HISTORIC PRESERVATION COMMISSION

SUBJECT: Historic Area Work Permit #656085, rear screen porch enclosure, window replacement and other alterations

MONTGOMERY COUNTY HISTORIC PRESERVATION COMMISSION
STAFF REPORT

DAYS RESIDENCE

A.4

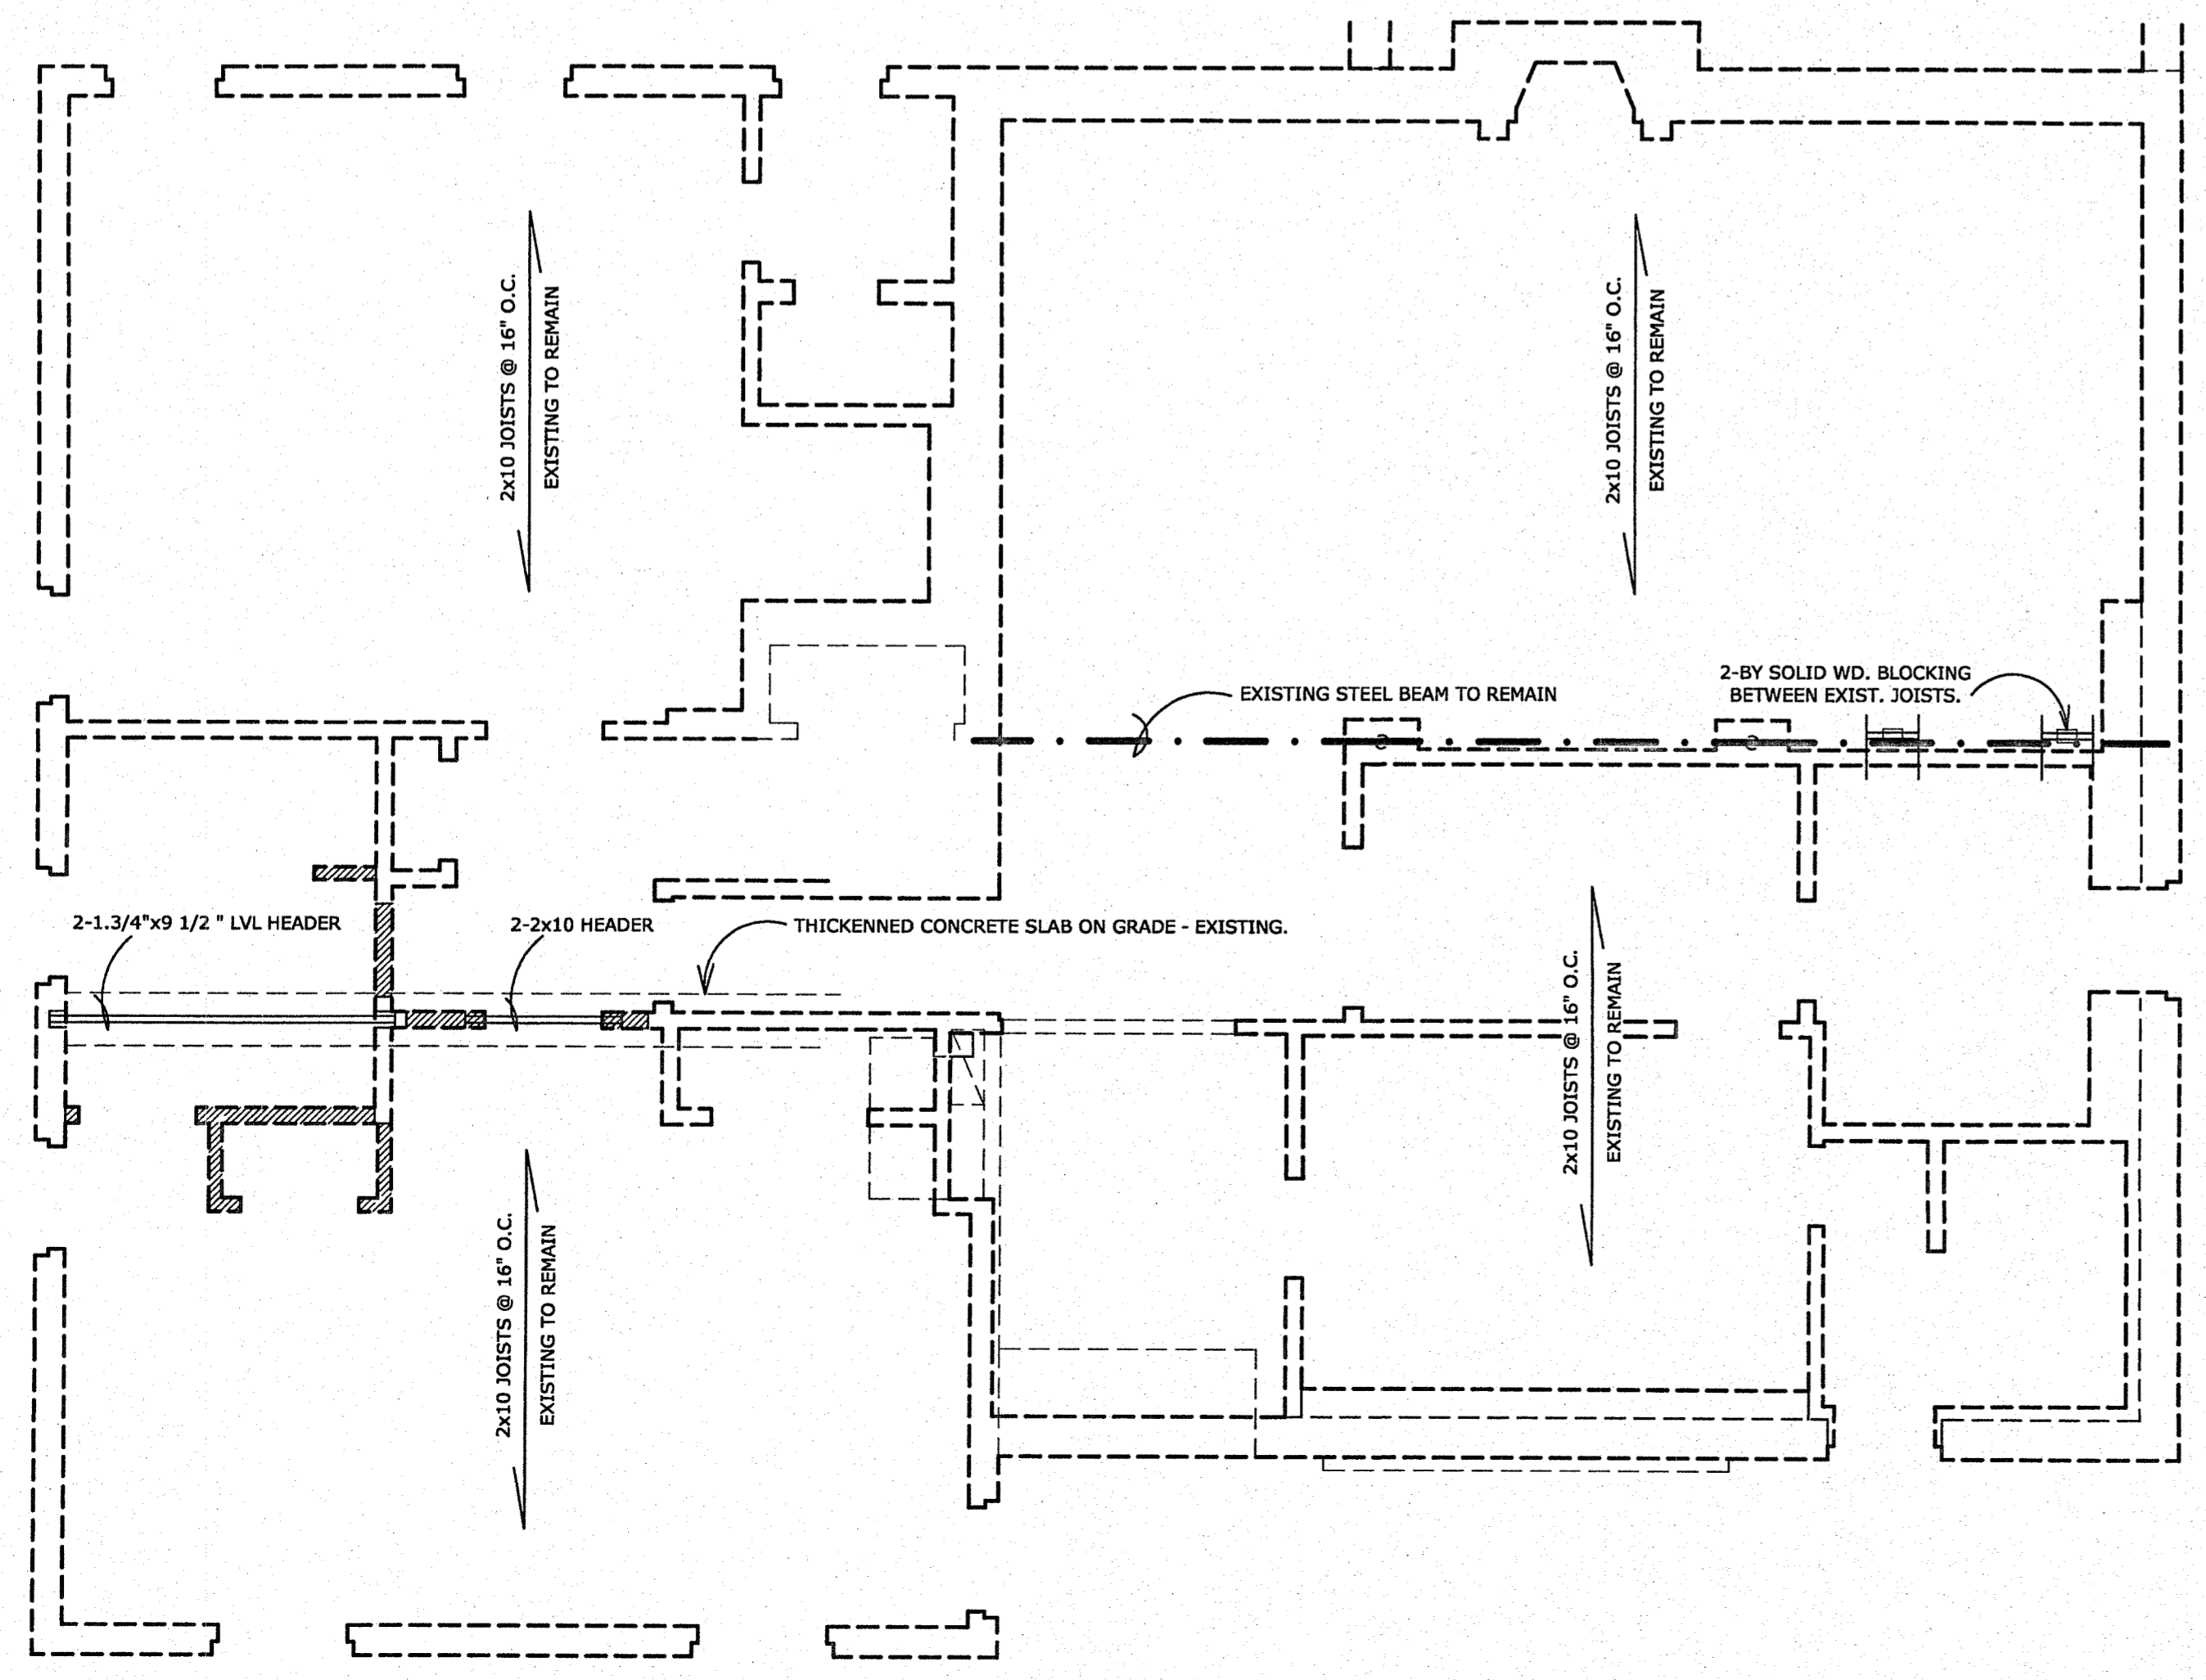
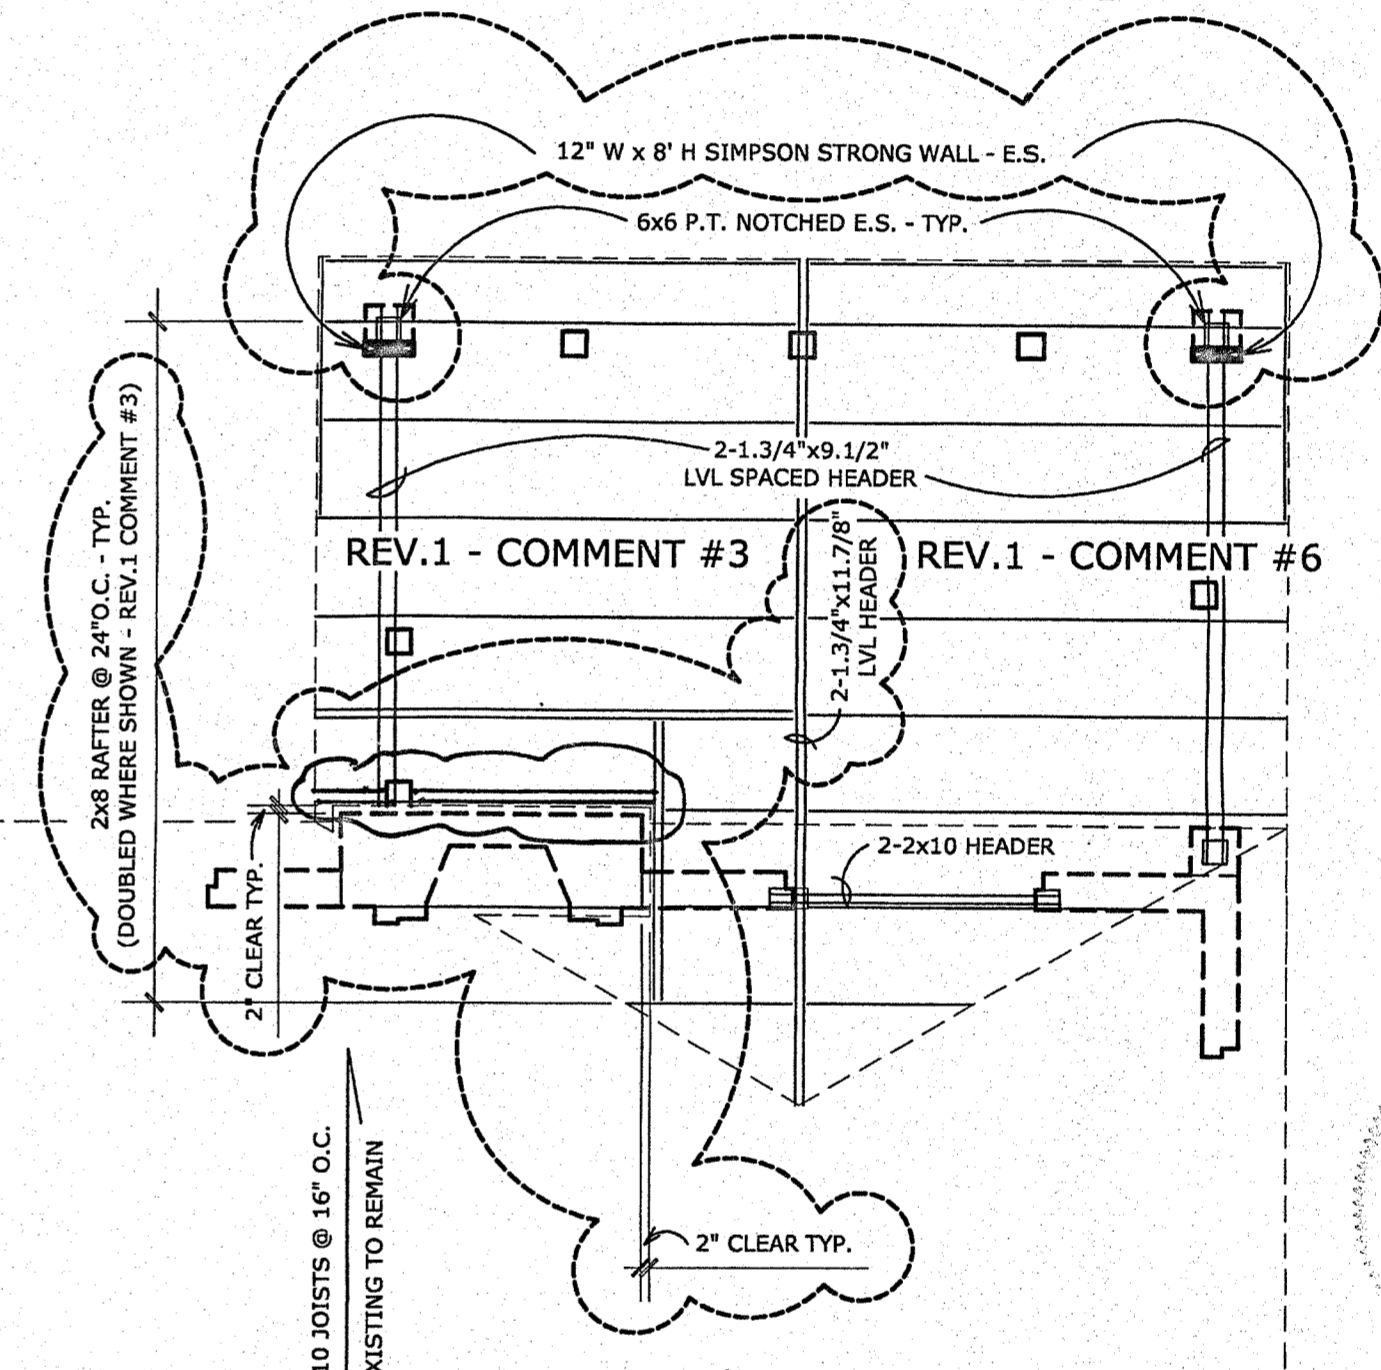
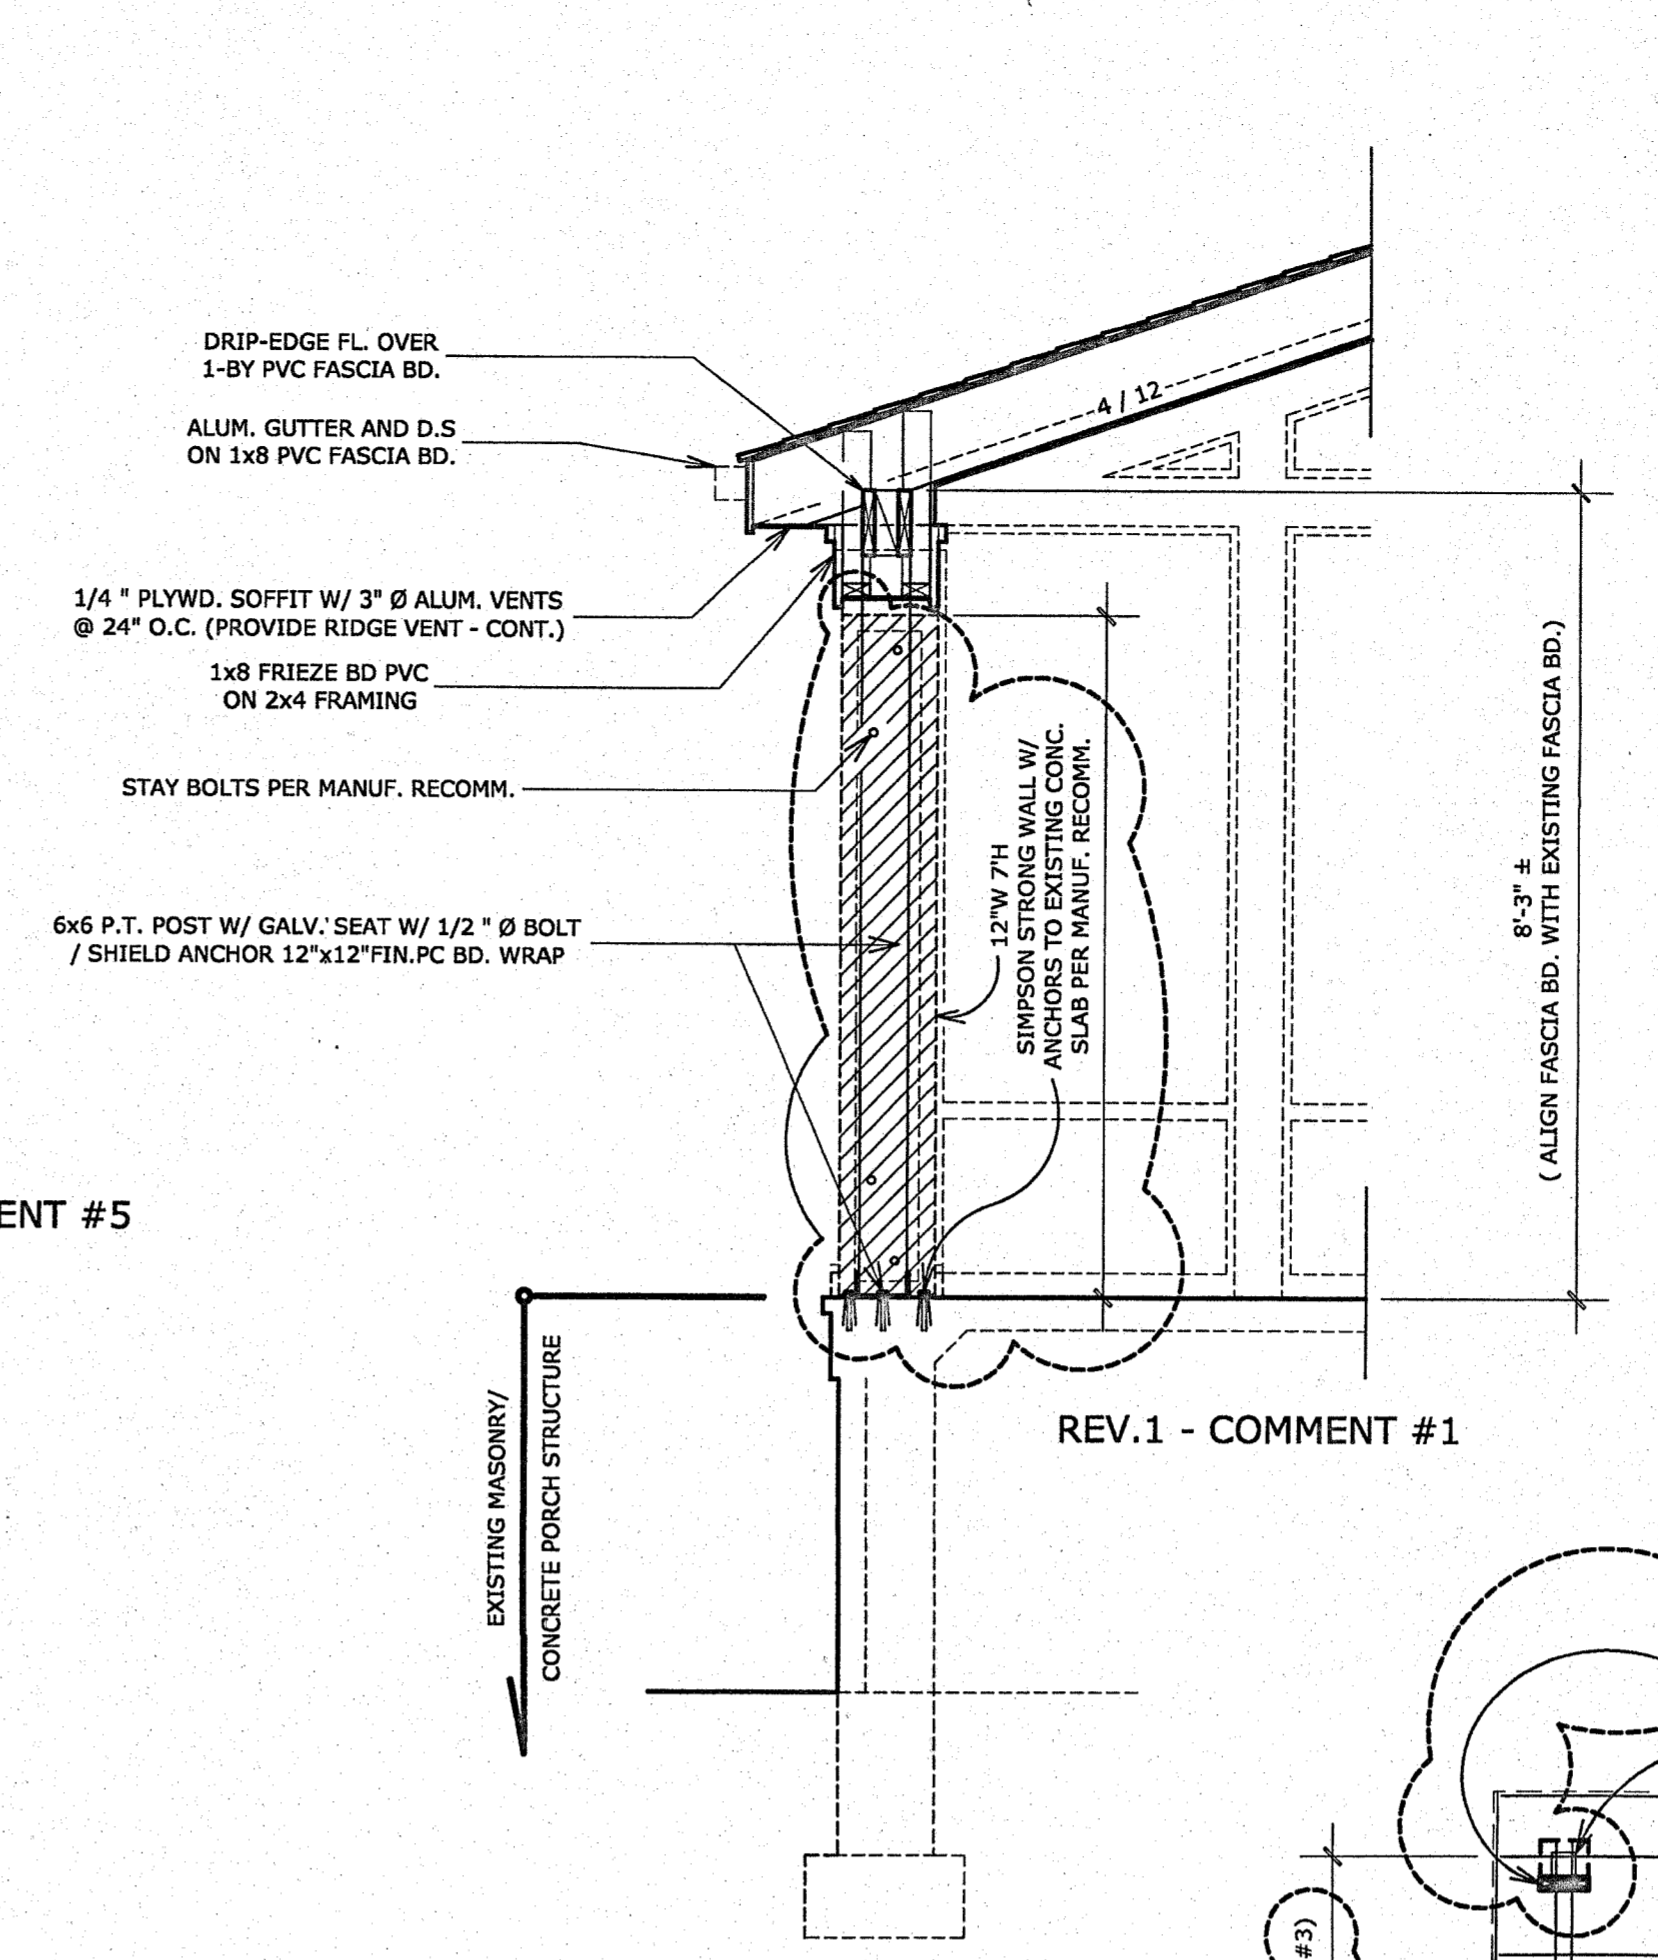
(ROOF FRAMING)
THESE PLANS MUST COMPLY WITH
SECTION R 802 OF THE 2012
1 & 2 FAMILY DWELLING
CODE AS AMENDED BY MONT. CO.

(ROOF TIE-DOWN)
THESE PLANS MUST COMPLY WITH
SECTION R 802.11 OF THE 2012
1 & 2 FAMILY DWELLING
CODE AS AMENDED BY MONT. CO.
